REPORT OF: URBAN DESIGN COMMISSION PRESENTED: March 7, 2007

TITLE: 301 South Ingersoll Street – PUD-SIP, **REFERRED:**

Seventy-Six Unit Apartment Development. **REREFERRED:**

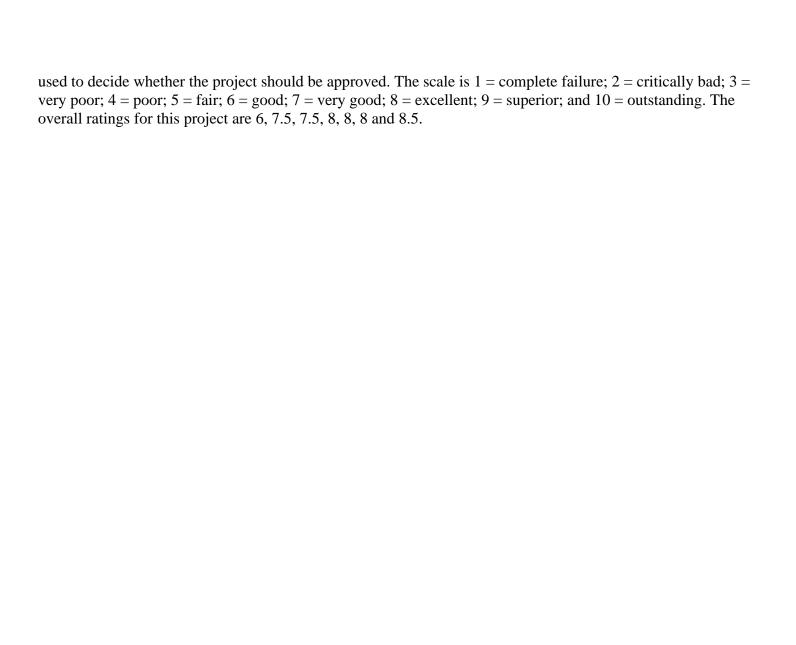
- Add a seating bench or planter at the corners of the interior courtyard circle.
- Consider making stair a vertically projecting bay on the side elevation at the courtyard of the 4-story element along with the elimination of brick on the first floor level.
- Resolve issue with brick versus wood frame façade alterations.

On a motion by Geer, seconded by March, the Urban Design Commission **GRANTED FINAL APPROVAL**. The motion was passed on a vote of (7-0-1) with Woods abstaining. The motion required addition of planters within the interior courtyard circle at the entry, the flexibility alternative to modify the side elevation at the courtyard on the 4-story element, a vertical projecting bay with the elimination of brick at the first floor level in addition to resolve of the issue relevant to brick versus wood frame façade alterations.
